Proposed update on Transmitter Power Excursion

Roberto Rodes, II-VI

November 9th, 2020

400G-FR4 OMA vs Overshoot

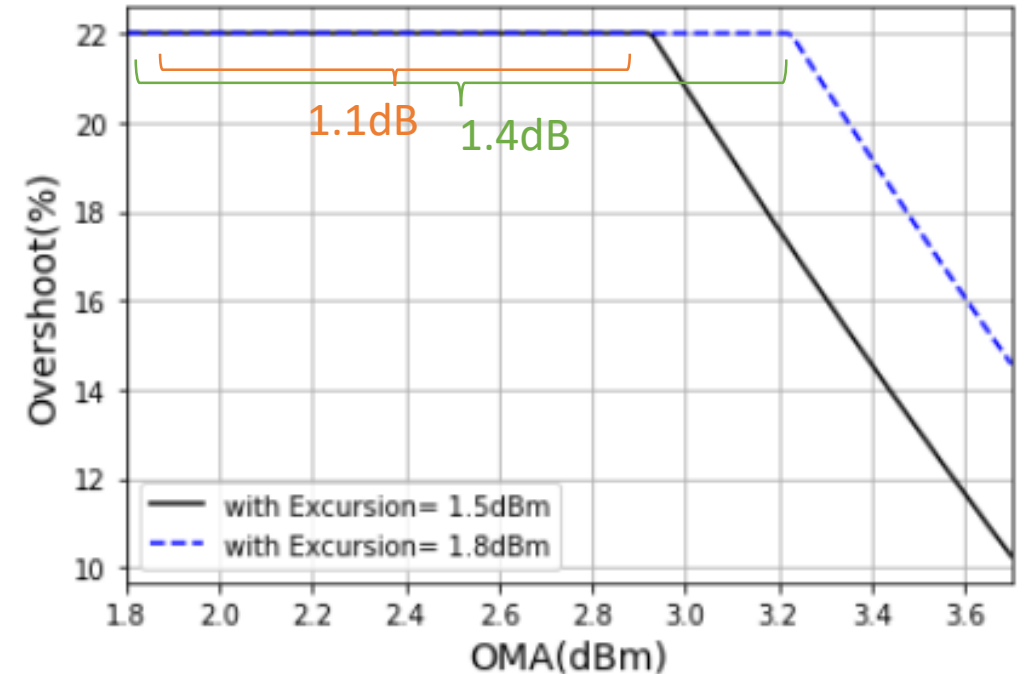
- ❑ Power excursion protects receivers from transmitters having, at the same time, maximum OMA and maximum overshoot
- ❑ With current Excursion spec of 1.5dBm, effective OMA range for maximum TDECQ and overshoot is only 1.1dB. This is very tight.
- ❑ Increasing power excursion spec to 1.8dBm would allow for 1.4dB OMA range
- ❑ Maximum allowed overshoot at max OMA would increase from ~10.5% to ~14.5%

- ❑ Increase power excursion from 1.5dBm to 1.8dBm in 400G-FR4.

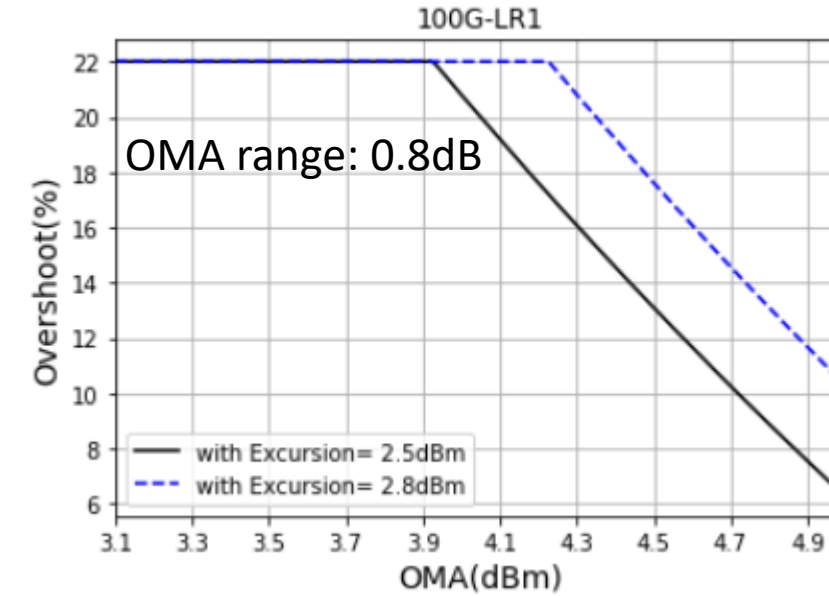
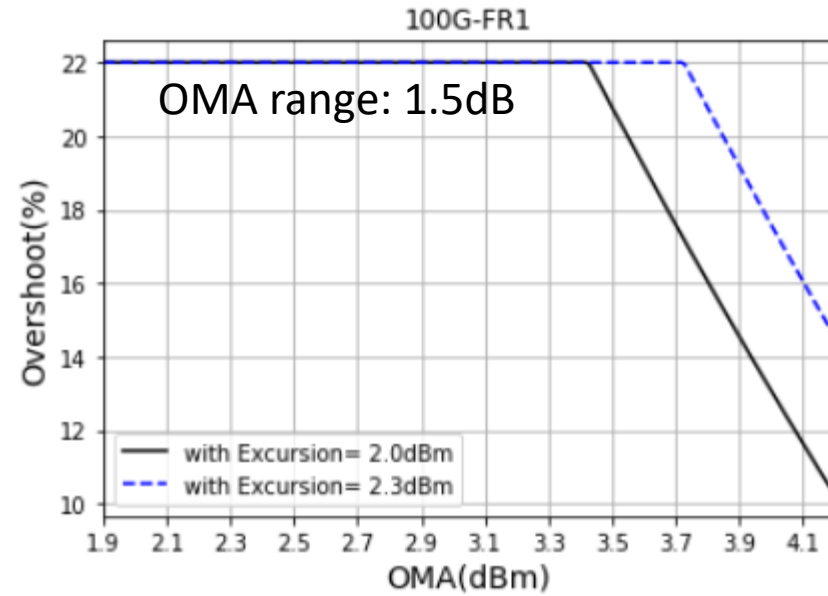
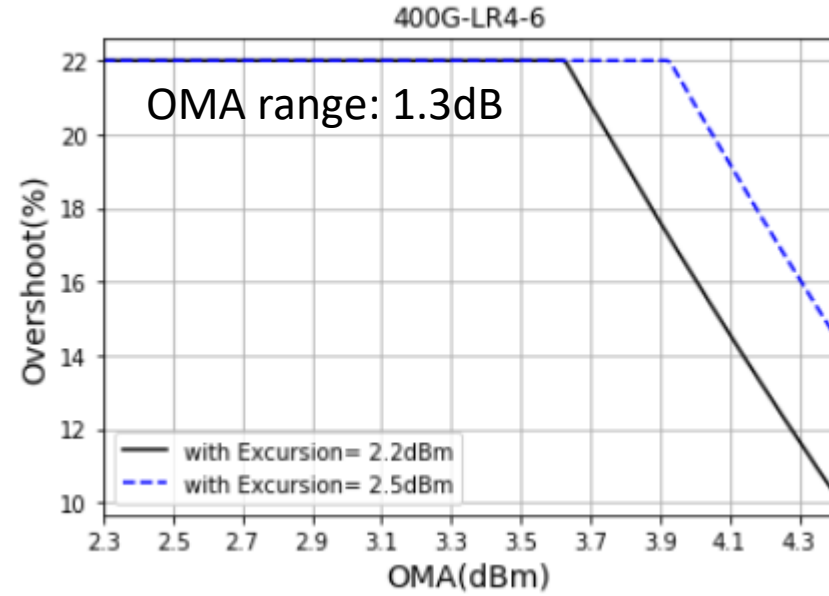
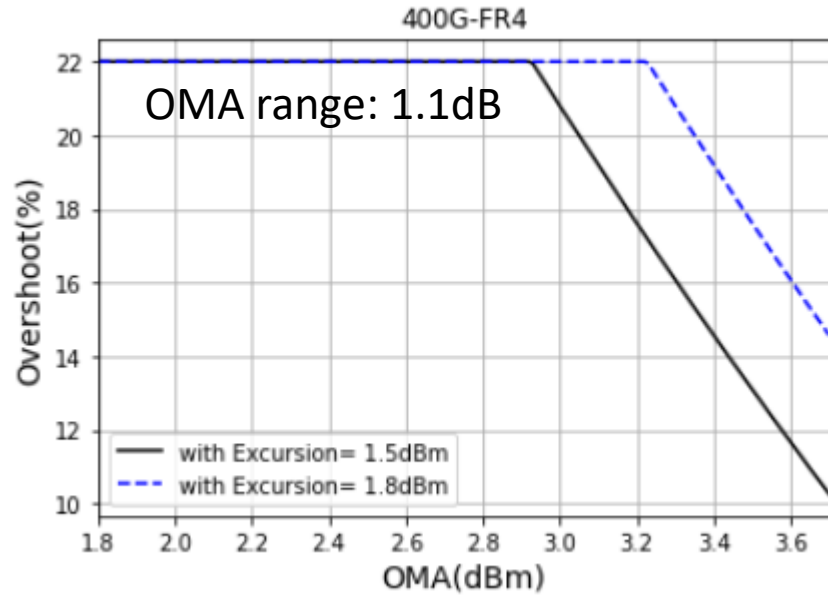
Recommendation:

- Increment power excursion by 0.3dB on FR4, LR4-6 and LR1
- No need to change FR1
